Reply to anonymous referee #1

This paper describes the history and technical aspects of an in-situ analyser that has been running in Lauder, NZ since January 2007. The spectrometer measures a variety of trace gas species, but this paper focuses on methane, carbon monoxide, and nitrous oxide. This paper describes a high quality, unique dataset that promises to be very valuable to the scientific community.

Fig15. (A) new:

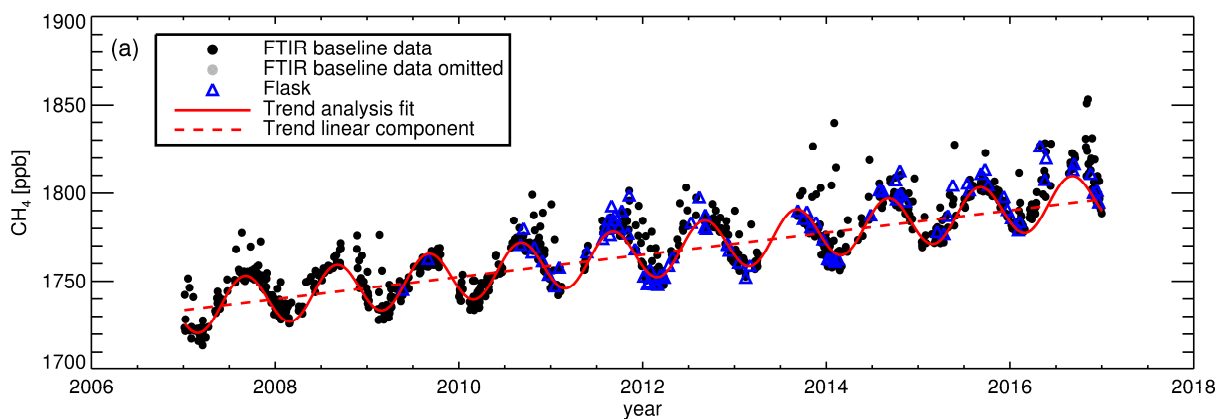
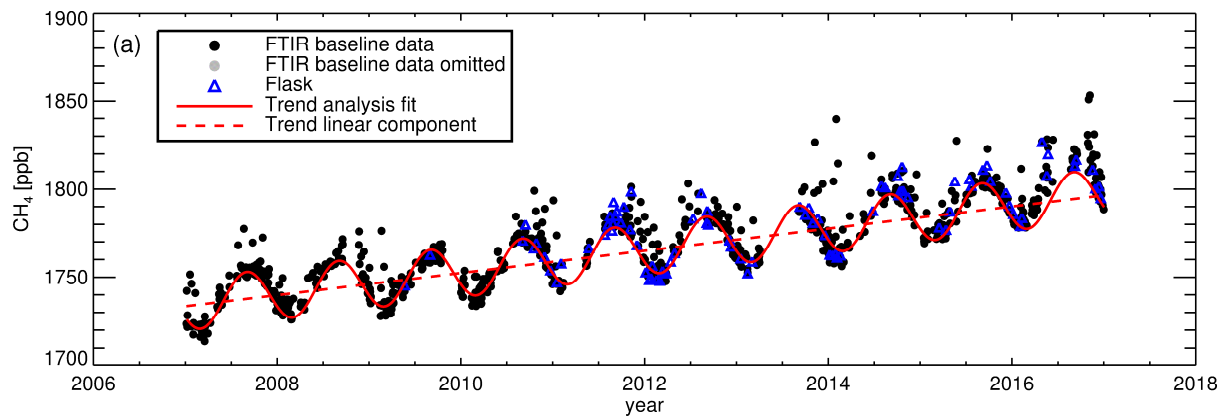
Fig 17: I had trouble seeing the blue triangles. Could you make them bigger?

Sure. The blue triangle (flask data) symbol size is increased by 33% in Figs. 15 a, b, c (any larger they could be disproportionate). The new figures are incorporated into the revised manuscript.

As an example, the new Fig 15a is displayed directly below, and the old fig15a beneath it (for comparison).
